# 1997 - 1999 Corvette: Service Bulletin: Loose or Missing Headlamp Door Bezel Plug

**Subject:** Loose or Missing Headlamp Door Bezel Plug (Install New Bezels and Plugs)

**Number:** 99-08-42-005

**Models:** 1997-99 Chevrolet Corvette

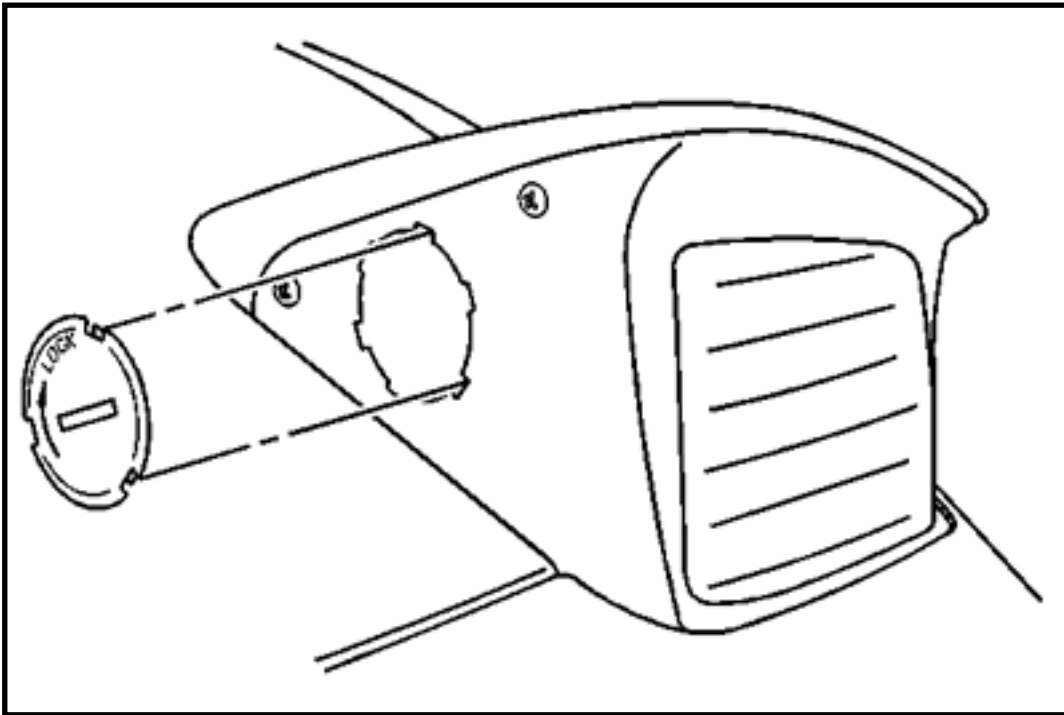
Two different size plugs have been used in production. Early production 1997 vehicles used a plug with a diameter of 24 mm (15/16 in), while later 1997 vehicles and all 1998 and 1999 vehicles use a larger 54 mm (2 1/8 in) diameter plug. Both size plugs have been replaced by a new design plug and, therefore, will no longer be available.

Using the following service procedure, replace both the left and right headlamp bezels with the new design bezels that have a large NOTCHED hole. The notched hole is required for installing a new design NOTCHED plug.

1. Open the engine compartment hood.
2. Turn the headlamp switch to the ON position (the headlamp doors will open and the lamps will illuminate).
3. Turn the headlamp switch back to the PARK lamp setting (headlamp doors will remain open).
4. Remove and discard both the left and the right headlamp bezels and plugs, following the information in the Body & Accessories section of the appropriate Service Manual.
5. Install the new left and right headlamp bezels.
6. Align the notches on the new plug with the notches in the opening in the new headlamp bezel.
7. Using a quarter or a flat-bladed screwdriver, slowly rotate the plug in

the direction shown by the arrow on the outside of the plug until a click can be heard or felt.

8. Repeat steps 6 & 7 on the other headlamp bezel.
9. Turn the headlamp switch to the OFF position (headlamp doors will close).
10. Close the engine compartment hood.
